SUBJECT: **INITIAL COMMENTS LETTER**

PROJECT NAME: RAINBOW SPRINGS EXPRESS GAS STATION

PROJECT #2019040012

APPLICATION: MAJOR SITE PLAN #26259

DEVELOPMENT PLAN

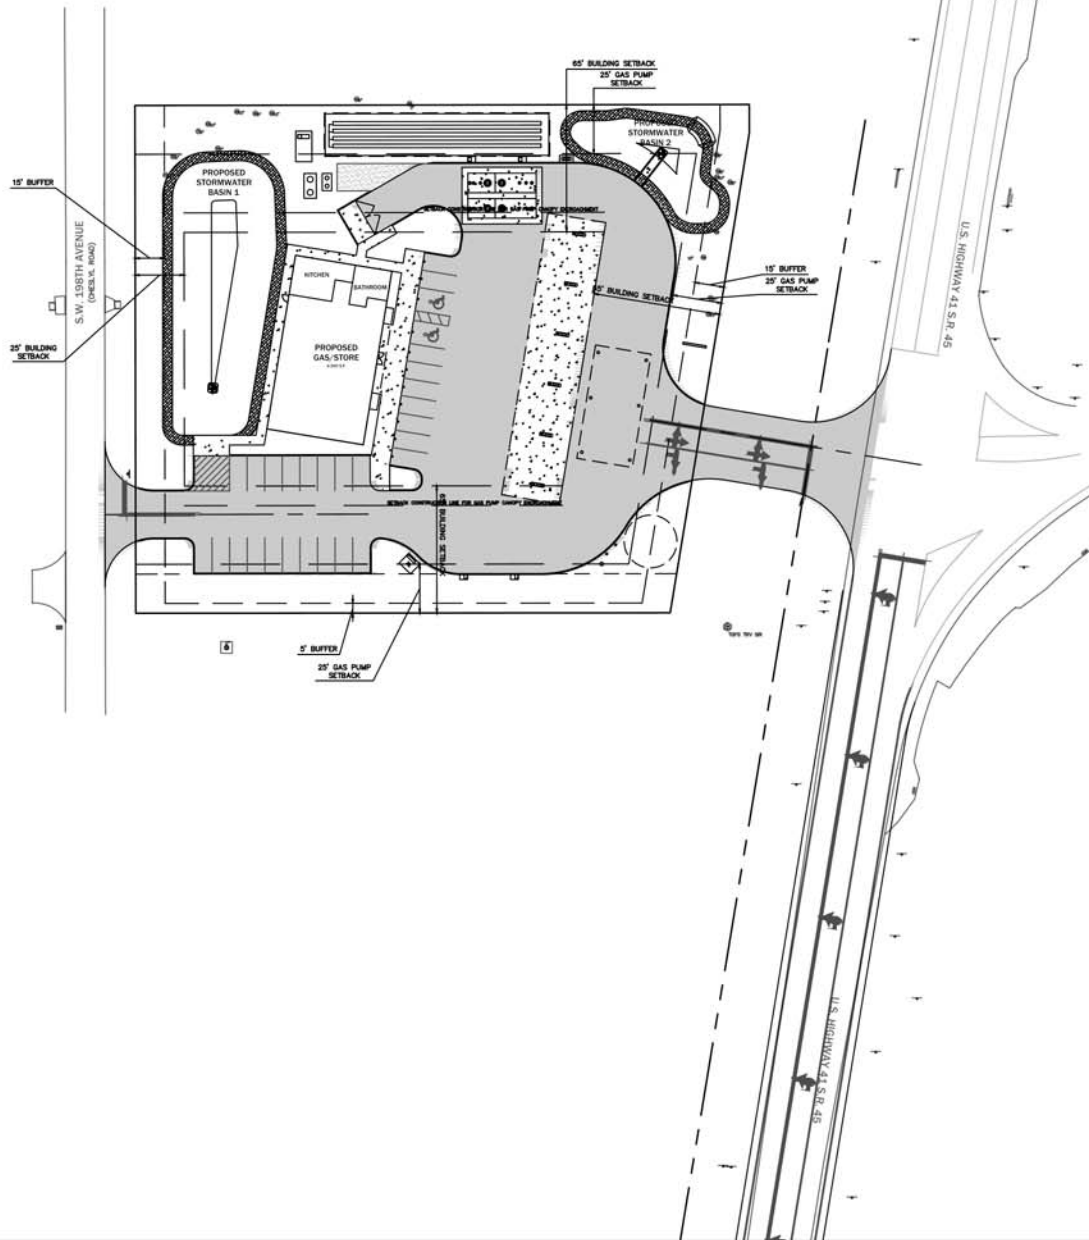
61. DEPARTMENT: ENGSUR - SURVEY REVIEW
REVIEW ITEM: 2.12.11 - Provide an aerial map of the site with a layout of the development
STATUS OF REVIEW: ENGINEER WILL COMPLY
REMARKS: Please overlay sheet C120 onto an aerial.

Designed: CSV Sheet No.: C130

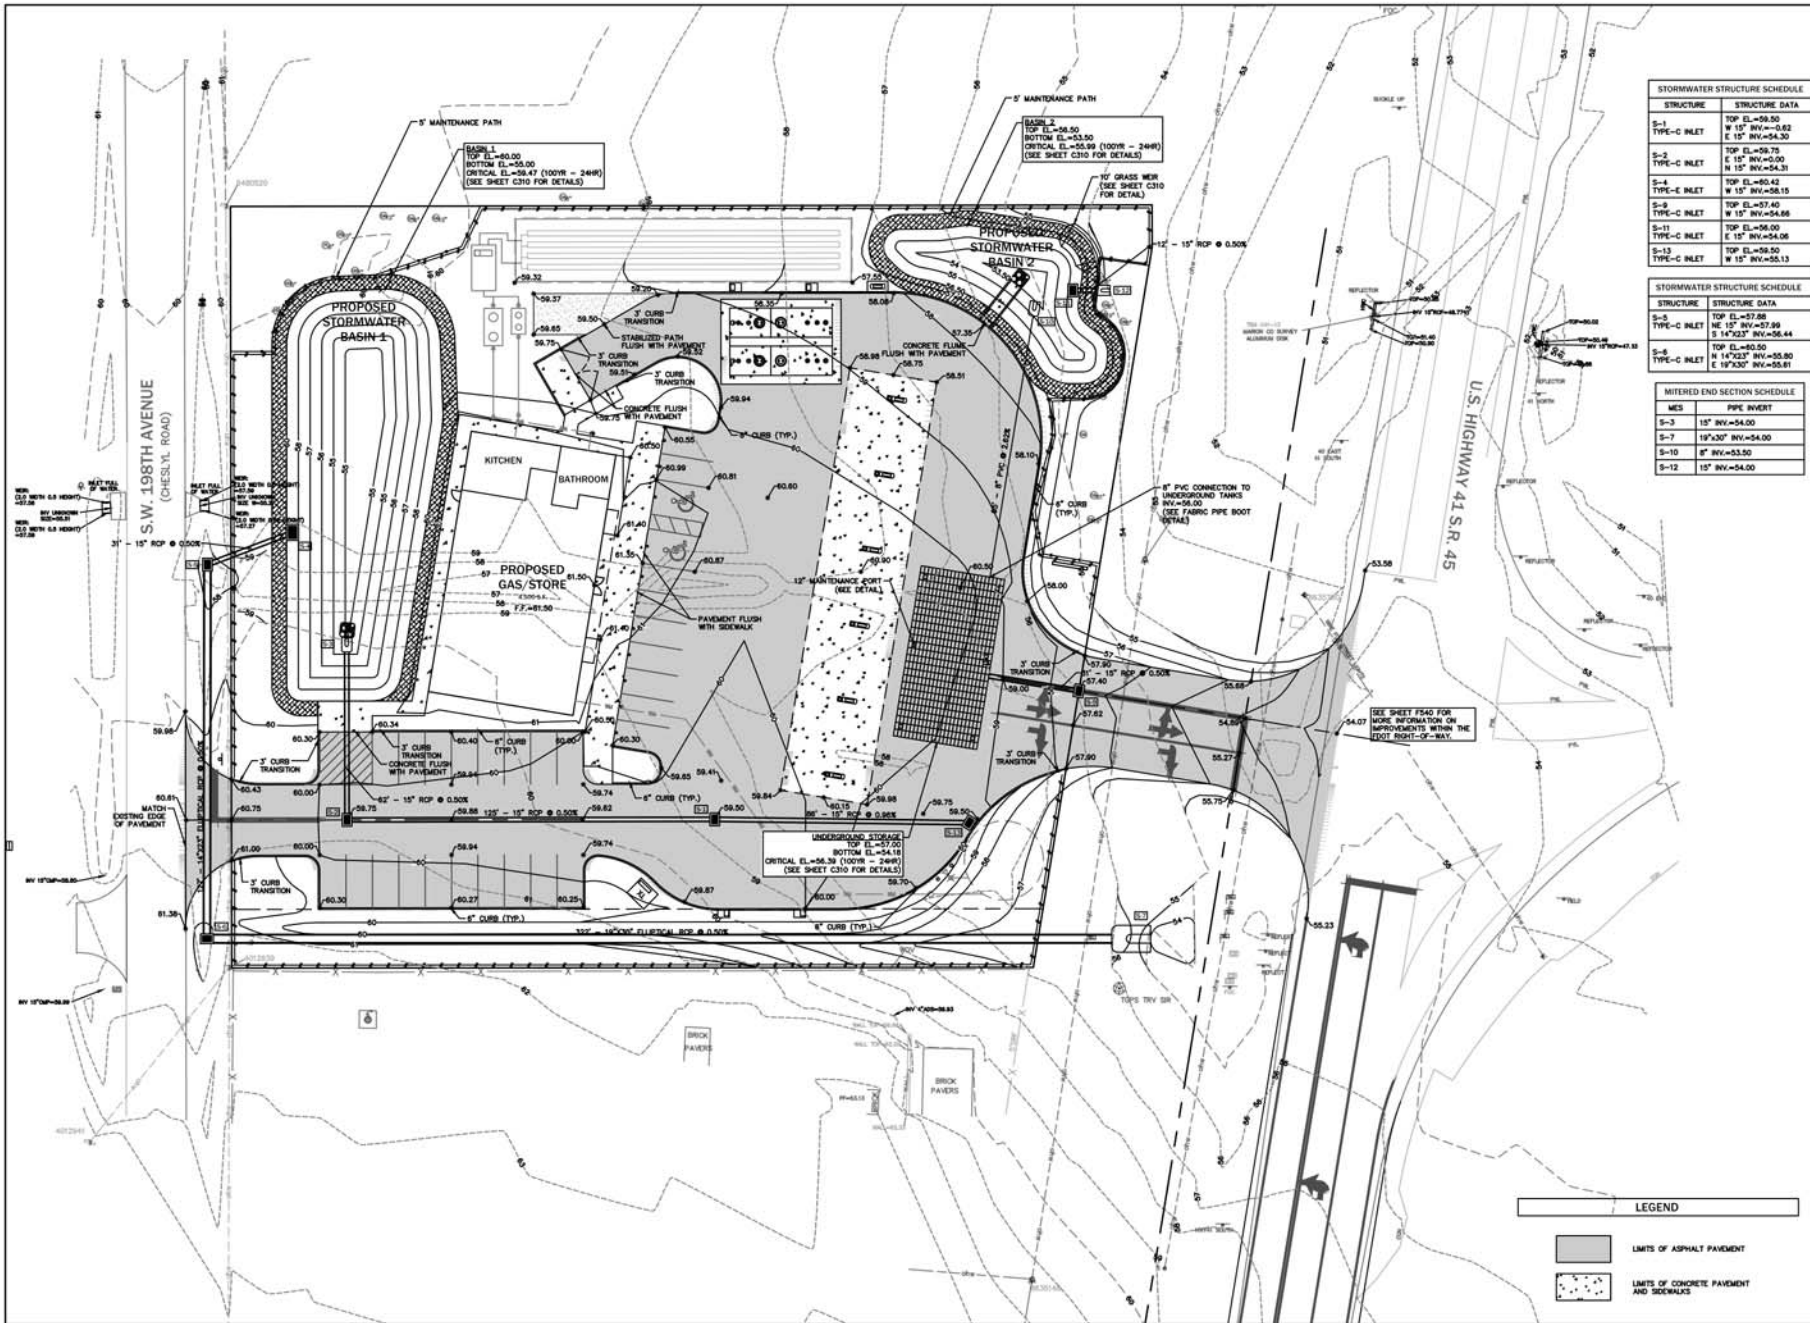
29. DEPARTMENT: ENGDRN - STORMWATER REVIEW
REVIEW ITEM: 6.13.2.A(11)(b) - Erosion Control
STATUS OF REVIEW: ENGINEER WILL COMPLY
REMARKS: Will the Demo and Tree Clearing Plan serve as the SWPPP for the duration of construction? Please show existing inlet on SW 19th Ave to be protected during construction.

BASIN DETAIL

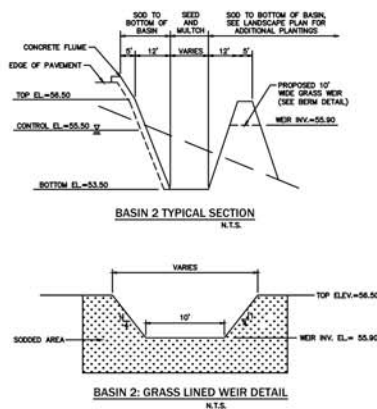
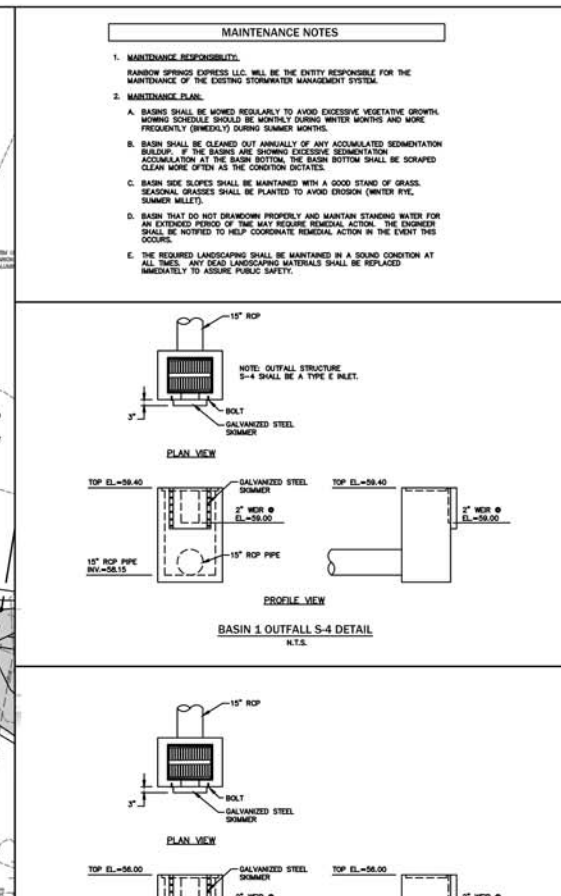
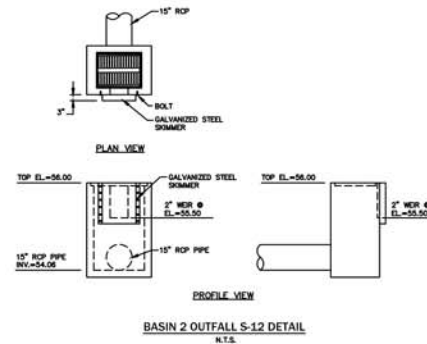
REMARKS: 1) Please add dimensions to the DRAs and Underground Storage area. 2) Please show soil boring locations with ID labels on the plan sheet. 3) Please show Basin 1 with sodded bottom in cross section. 4) Please label Design High Water at the 100 year, 24 hour storm in the DRA cross sections. 5) Please label the Estimated Seasonal High Water Table Elevation in the DRA cross sections.

Sheet title:
TREE MITIGATION

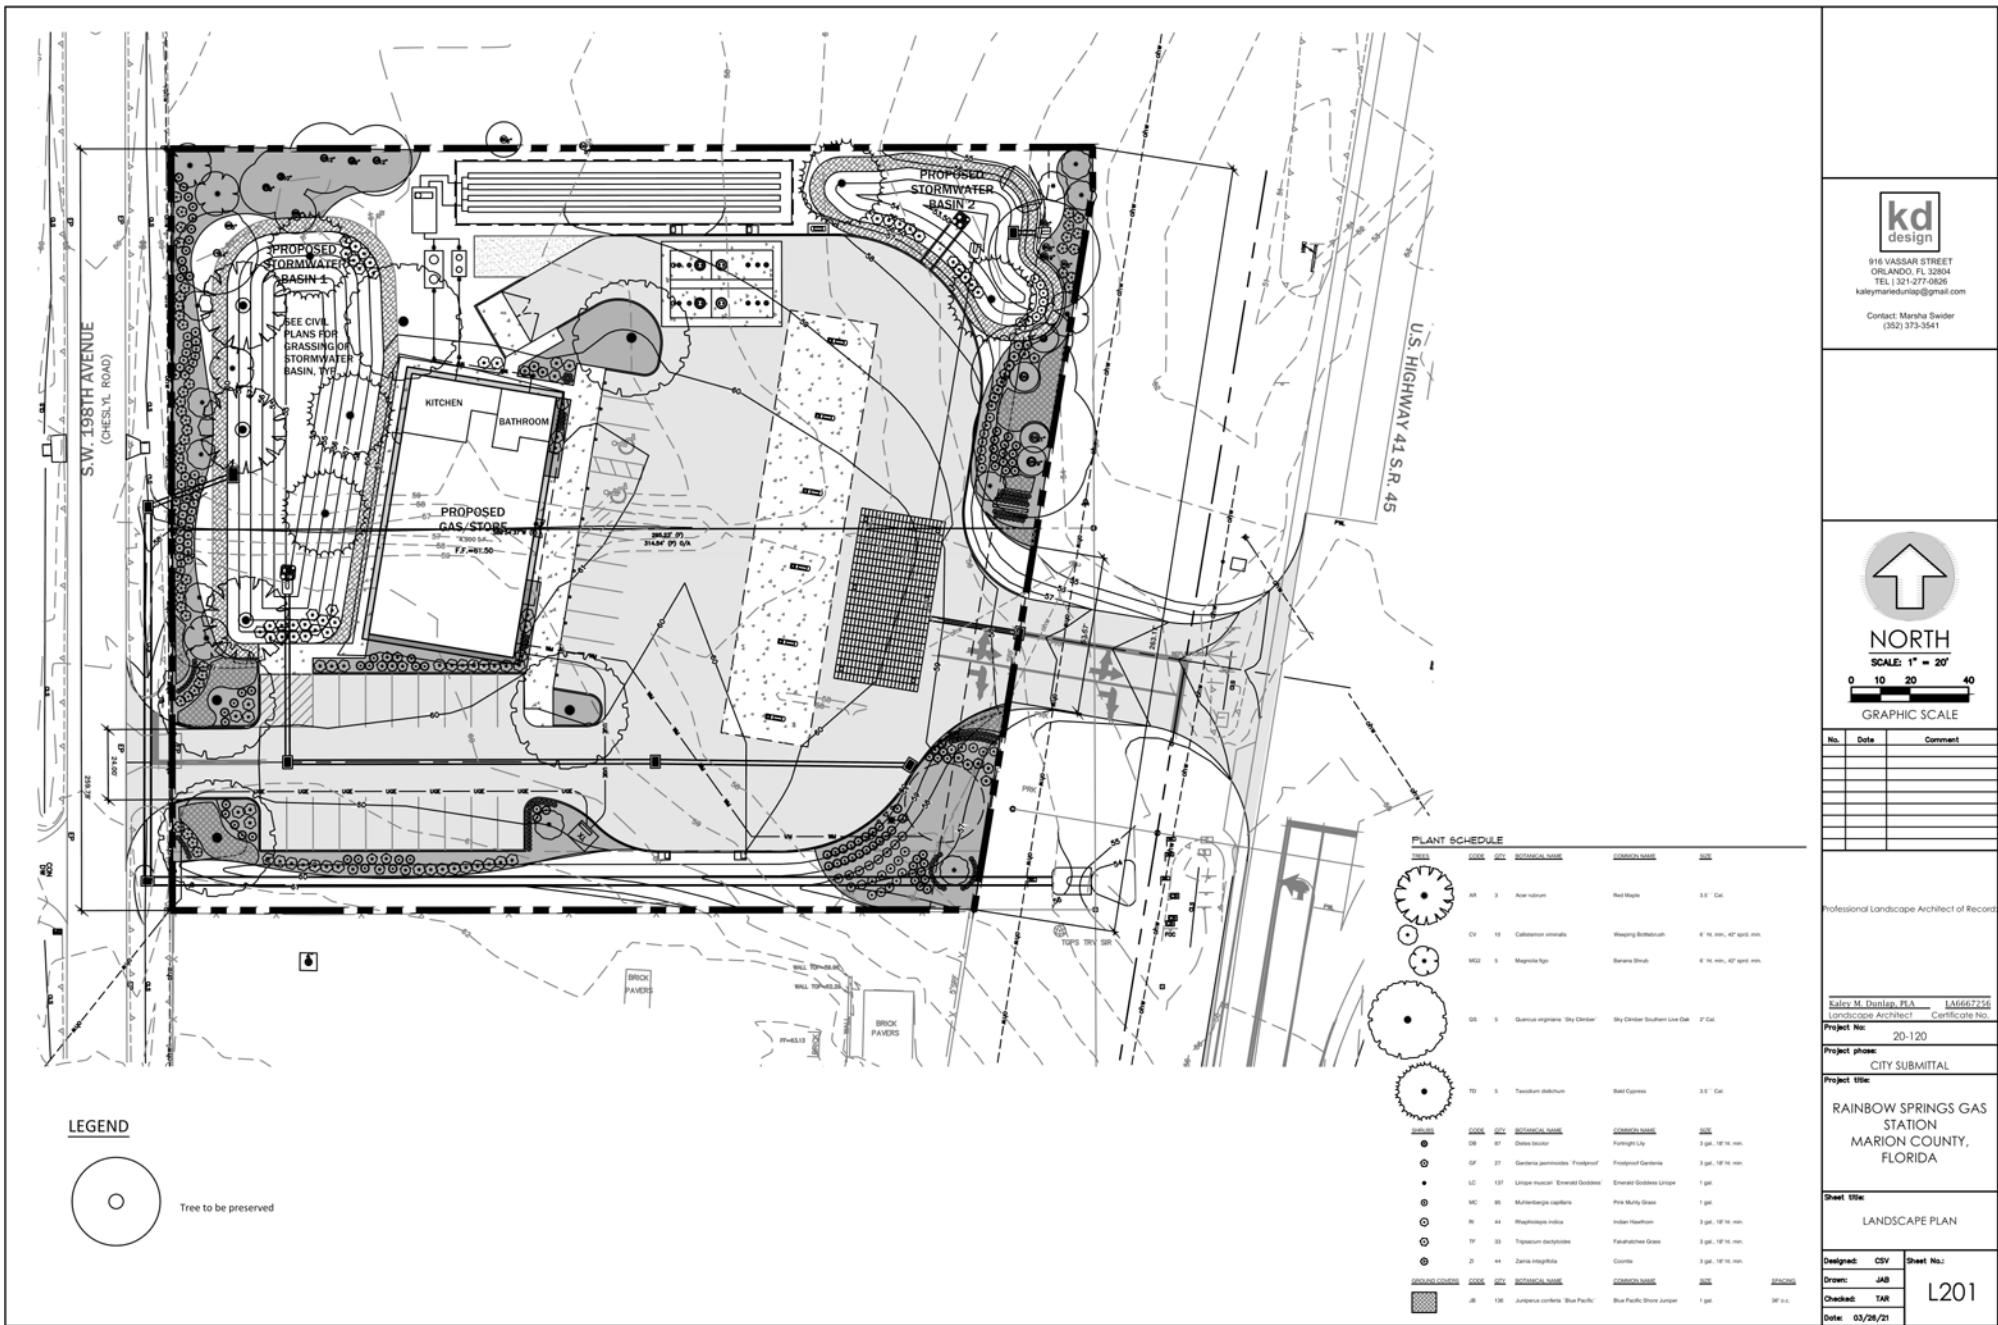
62. DEPARTMENT: LSCAPE - LANDSCAPE DESIGN AND IRRIGATION
REVIEW ITEM: 6.7.6 - Tree removal submittal requirements
STATUS OF REVIEW: ENGINEER WILL COMPLY
REMARKS: Tree types and sizes are obscured graphically. Please clarify on plans or provide a list of all the trees
